# Technical Review: Performance of the Composite Barrier Layers and Lateral Drainage Layers of the U.S. Department of Energy 2020 Performance Assessment for the Savannah River Site Saltstone Disposal Facility

April 18, 2023

Hans Arlt, Sr. Risk Analyst, U.S. Nuclear Regulatory Commission  
Stuart Stothoff, Principal Scientist, Center for Nuclear Waste Regulatory Analyses,  
Southwest Research Institute®

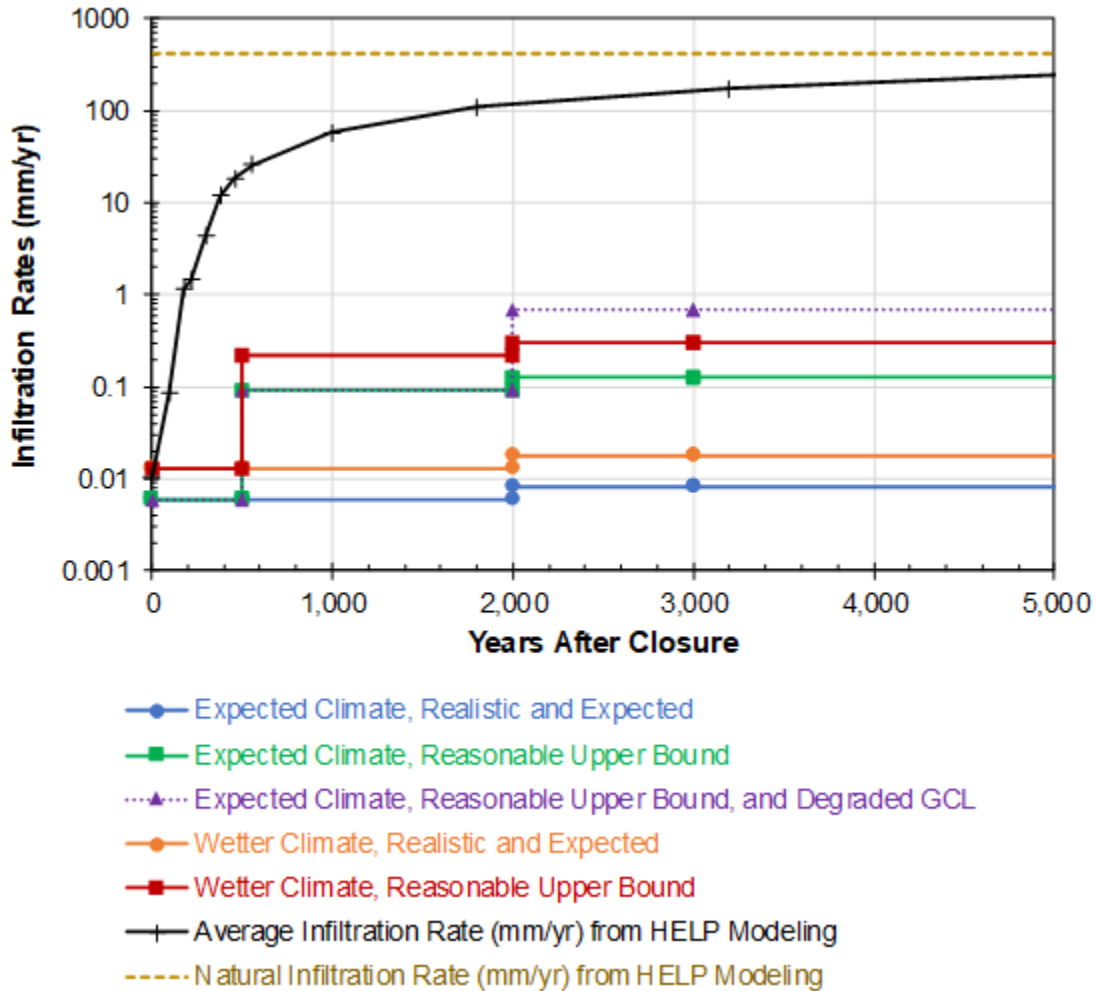
Inflow rates through the composite barrier layer that were calculated with the 2020 SDF PA Closure Cap Model are dramatically smaller than infiltration rates calculated with the 2009 SDF PA Closure Cap Model (

Figure Error! No text of specified style in document.-4**Error! Reference source not found.**) with every 2020 SDF PA inflow rate orders of magnitude smaller than the 2009 SDF PA inflow rate. In

Figure Error! No text of specified style in document.-4, the two uppermost curves represent the 2009 inflow calculated: (i) with backfill in place of the ULDL structure and (ii) with the ULDL structure in place (including the composite barrier layer). The remaining curves are from the 2020 SDF PA, generated with two assumptions about climate (percolation rate of 400 and 650 mm/yr [16 – 26 in./yr]), ULDL saturated conductivity (0.01 and 0.05 cm/s [0.004 – 0.02 in/s]), HDPE defect diameter (2 and 10 mm [0.08 – 0.4 in]), and GCL saturated hydraulic conductivity ( $10^{-9}$  and  $10^{-8}$  cm/s [ $0.4 \times 10^{-9}$  and  $0.4 \times 10^{-8}$  in/s]).

**Figure Error! No text of specified style in document.-5: Leakage Observations from Double-Lined Landfills in Upstate New York (Beck, 2015) Partitioned into Cells with and without ELL Surveys (data are fitted with exponential exceedance fractions, broken at 6 mm/yr (0.2 in./yr))**

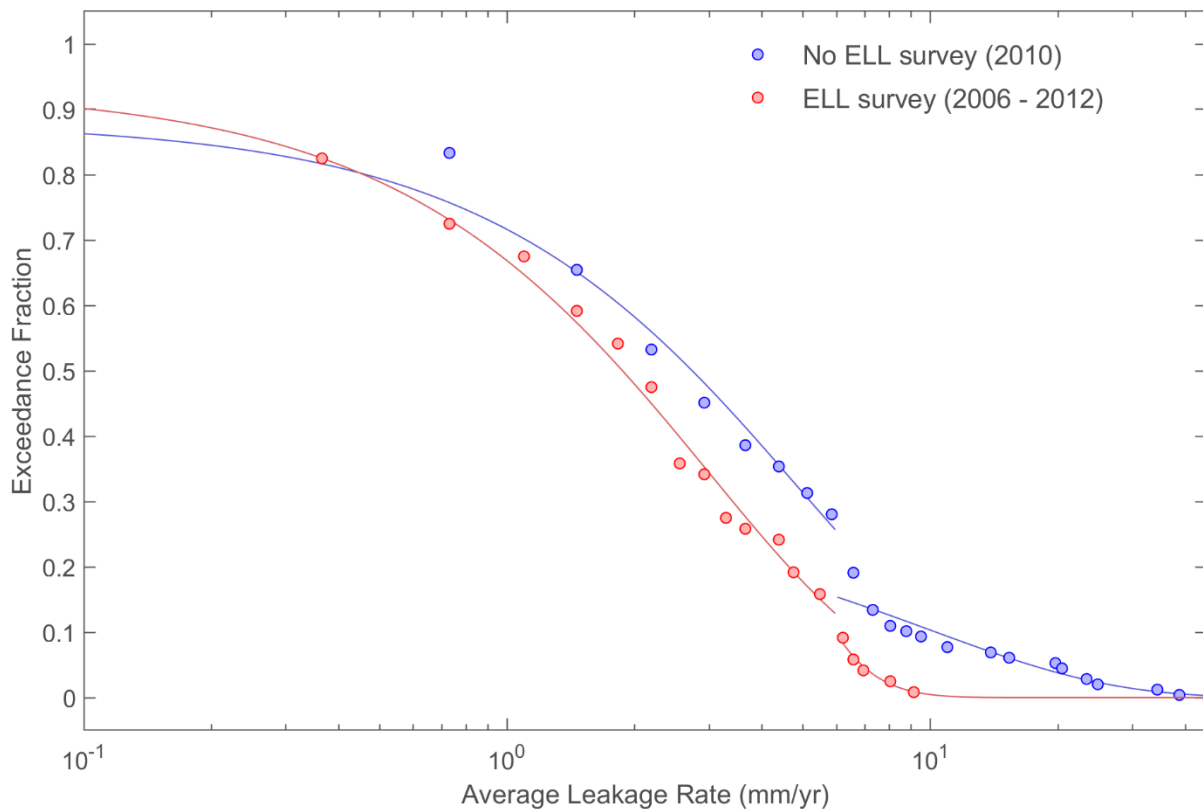
Figure Error! No text of specified style in document.-5 contrasts the exceedance fraction for cells that underwent an electrical leak location (ELL) survey with cells that did not get surveyed, suggesting that repairs subsequent to the survey tend to mitigate large leaks. Beck (2015) suggested that leakage is underestimated through cells lacking an ELL survey, because those

cells are from older cells with very thick waste (which reduces flow) and some cells may have been capped. Gilson-Beck (2019) reported earlier data by Bonaparte and Gross (1993) from 14 sites, suggesting that more recent technology may have reduced leakage rates. Data from 2010 suggests that 27 percent exceeded 1.8 mm/yr (0.071 in./yr) and 3 percent was between 7.3 and 18.3 mm/yr (0.29 and 0.721 in./yr). Data from these studies illustrate that HDPE geomembrane quality and installation practices have improved over time. These measured leakage rates, representative of initial infiltration rates, have a median infiltration rate of ~2 mm/yr (0.08 in./yr), two orders of magnitude larger than any initial infiltration rate in the 2020 SDF PA's Closure Cap Model (

Figure Error! No text of specified style in document.-) and several times larger than the upper bound infiltration with both the HDPE geomembrane layer and the GCL fully degraded.

**Figure 4-2: Calculated Volumetric Flow through SDS 7 for 54 Flow Cases Varying Infiltration Rate, Cementitious Degradation Rate, Backfill Ksat, and Saltstone Ksat<sup>3</sup>**

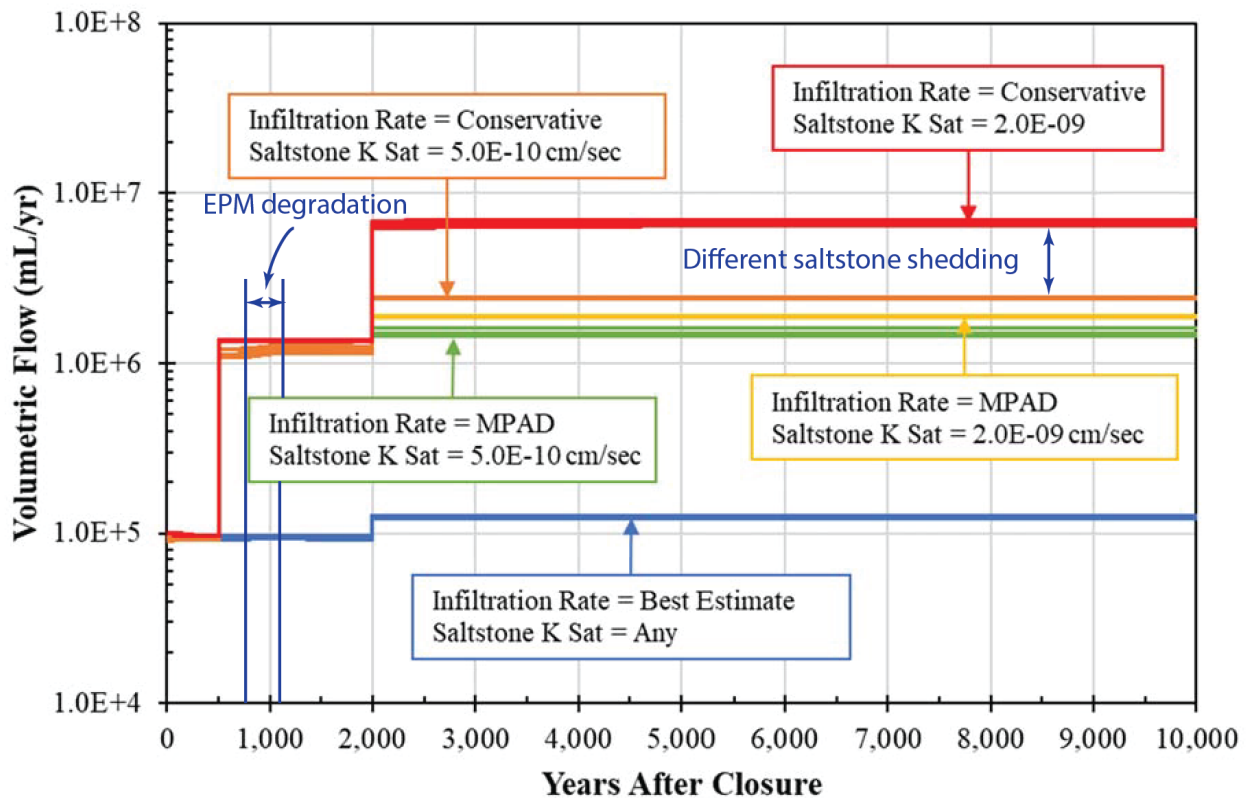
Although the method for calculating the Ksat values of the barrier EPMs was not explained in detail, the modeled barriers do not appear to significantly impede flow through the disposal structures (at least when no fast pathways that contribute to saltstone degradation are included). The lack of influence can be seen in comparisons of calculated intermediate flow

rates through various levels of the disposal structures (Section 4.4.4.4, 2020 SDF PA). The combined barrier effect would be most clearly seen as gradually increasing flow through the disposal structures from year 750 through year 1100, as the barrier EPM Ksat values increase (the section labeled “EPM degradation” in Figure 4-2). The modeled increase is, at most, barely discernable, implying that the barrier effect is minimal. Once the barriers are fully degraded, the saltstone Ksat controls how much water is able to pass through the disposal structures; the remainder diverts within the LLDL in the DOE model.

**Figure 4-3: Calculated: (a) infiltration rate and (b) head (as perched water table thickness) representing the initial (0–500 years) and fully degraded (>2000 years) Compliance Case property sets in Table 4-1<sup>4</sup>**

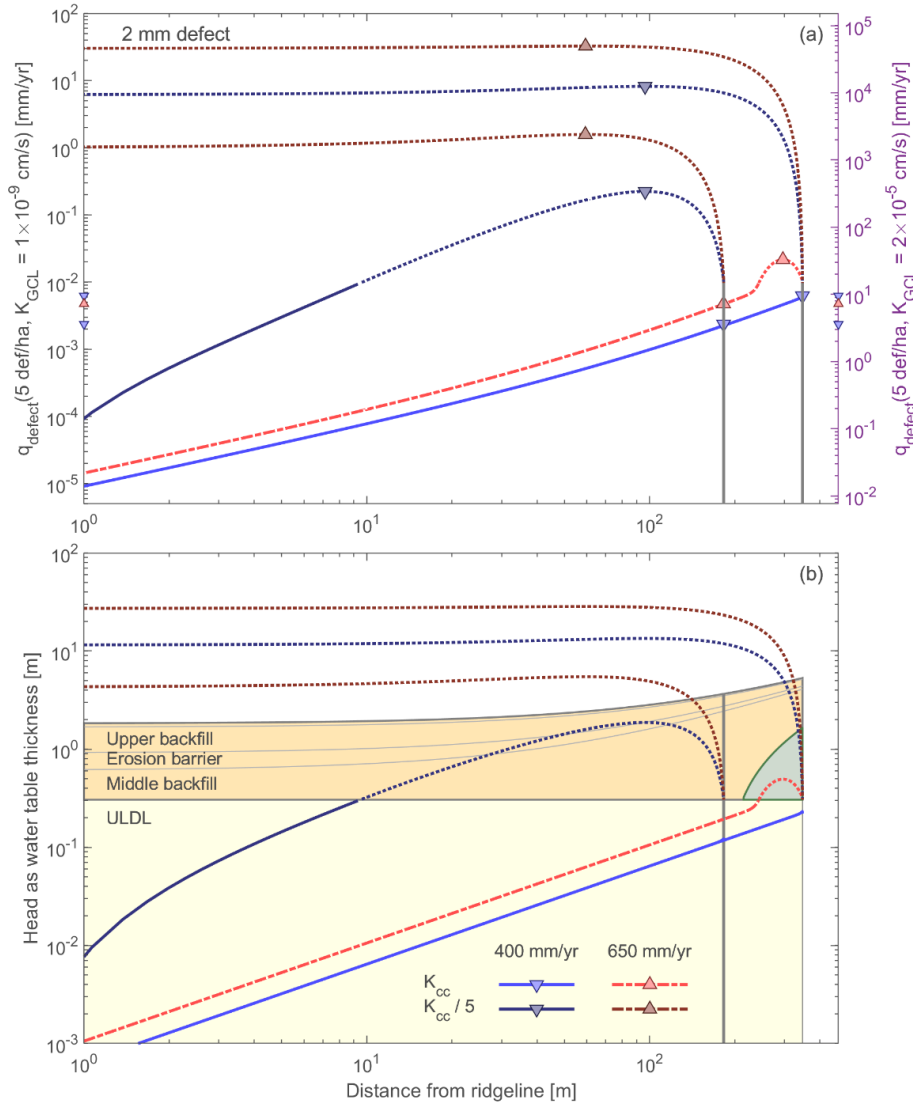
**Error! Reference source not found.**4-3a shows the infiltration rate that the Giroud (1997) equation would provide for a 2-mm (0.08-in) defect at the calculated water table thickness at each slope location (assuming no other defects exist), scaled to the area of 5 defects/ha. The left axis indicates the infiltration rate with the GCL hydraulic conductivity representing a new GCL ( $10^{-9}$  cm/s [ $4 \times 10^{-10}$  in/s]); the right axis indicates the infiltration rate for the identical assumptions except that the GCL is highly degraded ( $2 \times 10^{-5}$  cm/s [ $8 \times 10^{-6}$  in/s], approximately the average GCL-only hydraulic conductivity in Figure ). The location of the peak calculated infiltration is indicated with a symbol, which is echoed on the left and right axes for simulations with a fully unconfined perched water table. **Error! Reference source not found.**4-3b from the 2021 CNWRA report ([ML21287A328](#)) shows the head in the ULDL at each location of the slope, represented as the equivalent water table thickness, given the provided inflow rate with no losses through defects. The ULDL is fully saturated (i.e., the perched water table is confined) where the curves indicating infiltration and water table thickness are dotted. In common with the 2020 SDF PA approach, the calculated infiltration value does not account for infiltration losses through other defects and the calculated head value does not account for the local gradients near the defect. The calculated infiltration value can be larger than the assumed inflow rates under confined conditions, because confined conditions allow upslope flow and the area for scaling is much smaller than the cap area.
